2803 EDGEWATER C I 5-2019-0055 INTERESTED PARTY SUGGESTIONS – JAN 13, 2020

Subject: Mark Odom Plans for 2803 Edgewater Drive

The purpose of this letter is to provide my review comments on the plans prepared for the referenced project. My review was focused on drainage and related environmental concerns. You made design documents available for my review (via Dropbox). The files found are related to a Board of Adjustment (BOA) Case No. C15-2019-0055 ADV PACKET Jan 13 copy.

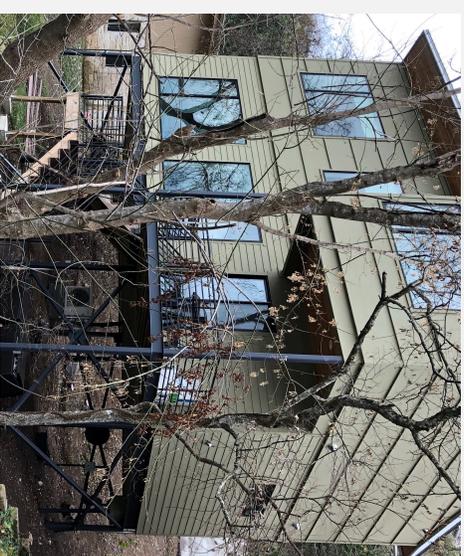
The lot is NOT unique. The hardships are not unique. There are two (2) other lots on Edgewater, one owned by the applicants, which have the exact same characteristics.
